ALERT SERVICE BULLETIN

**SUBJECT: REVISION "A" TO ALERT SERVICE BULLETIN ASB 206L-07-146:
POWER TURBINE RPM (N2) STEADY STATE OPERATION
AVOIDANCE, INTRODUCTION OF.**

NO. 206L-07-146

DATE	JAN 15, 2008
REV	A

Figure 1 – Typical 206L Instrument Panel Layout
(May vary depending on model and serial number applicability)

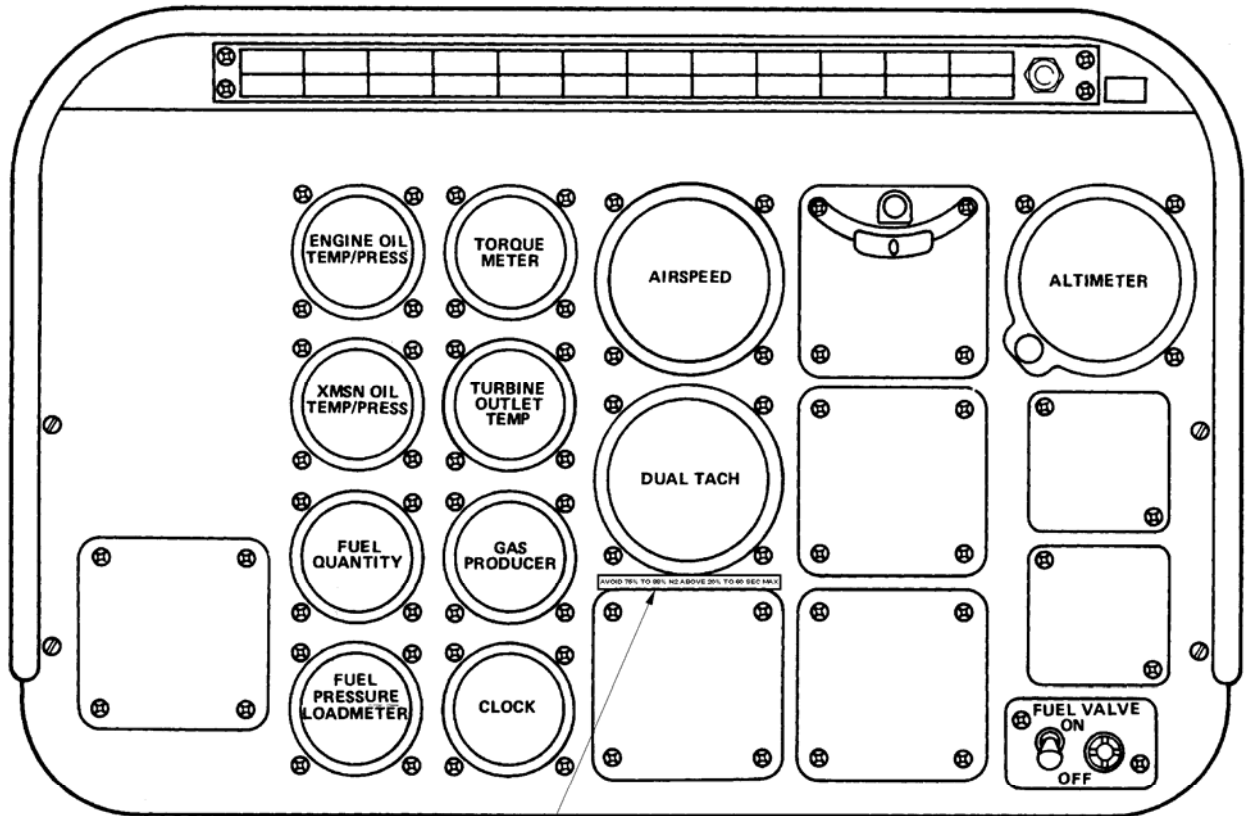
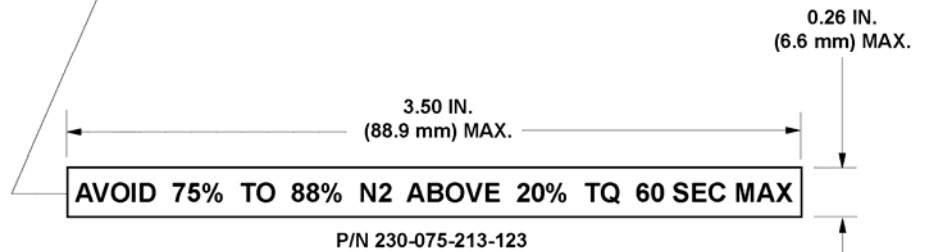
Revision "A" to this bulletin introduces a new decal to show the speed avoid range is not applicable for engine operation at or below 85 shaft horsepower (equivalent to 20% torque).

1. Remove previously installed 230-075-213-119 decal and discard.
2. Install decal 230-075-213-123 on the instrument panel as shown in Figure 1, below the NR/N2 dual tachometer. Sealer C-349 shall be applied over the installed decal.

1. One decal is provided with this bulletin.
2. The decal may be locally manufactured using lettering of white color (No. 17875) on black background color (No. 17038). Characters to be 10 point Spartan blackfont. Color per FED STD 595. The text for the decal is detailed in Figure 1 and should be in capital letters.
